Well Name: SILVER MEDAL	Well Location: T24N / R10W / SEC 27 / SWSW / 36.27887 / -107.889908	County or Parish/State: SAN JUAN / NM
Well Number: 1	Type of Well: OIL WELL	Allottee or Tribe Name:
Lease Number: NMNM21741	Unit or CA Name:	Unit or CA Number:
US Well Number: 300452603400S1	Operator: DUGAN PRODUCTION CORPORATION

Sundry ID: 2793503

Type of Submission: Notice of Intent	Type of Action: Plug and Abandonment
Date Sundry Submitted: 06/04/2024	Time Sundry Submitted: 10:03
Date proposed operation will begin: 06/17/2024

Attachment to notice of Intention to Abandon

Planned P&A Schematic**Silver Medal #1**

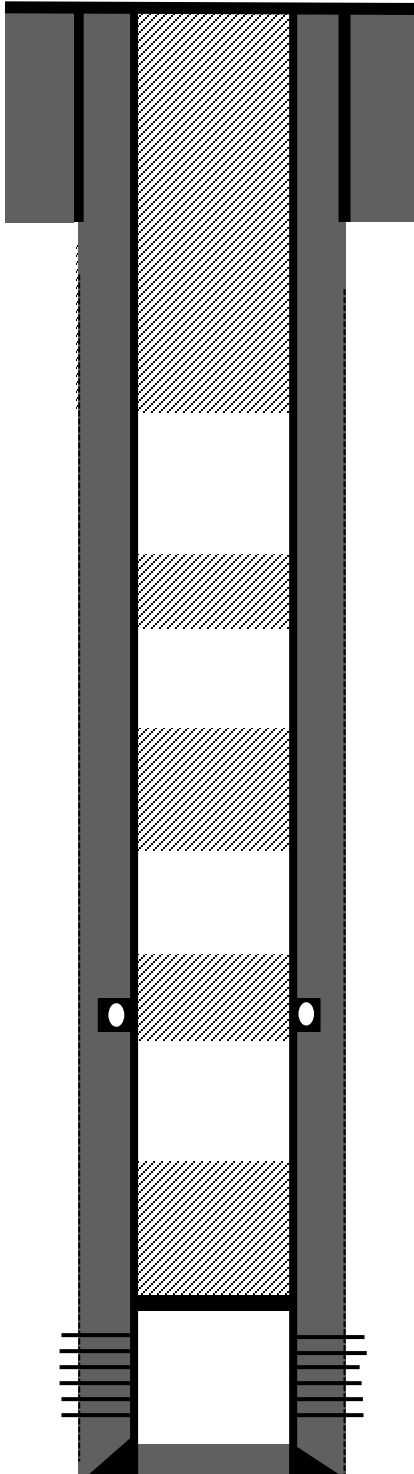
You are also required to place cement excesses per 4.2 and 4.4 of the attached General Requirements.
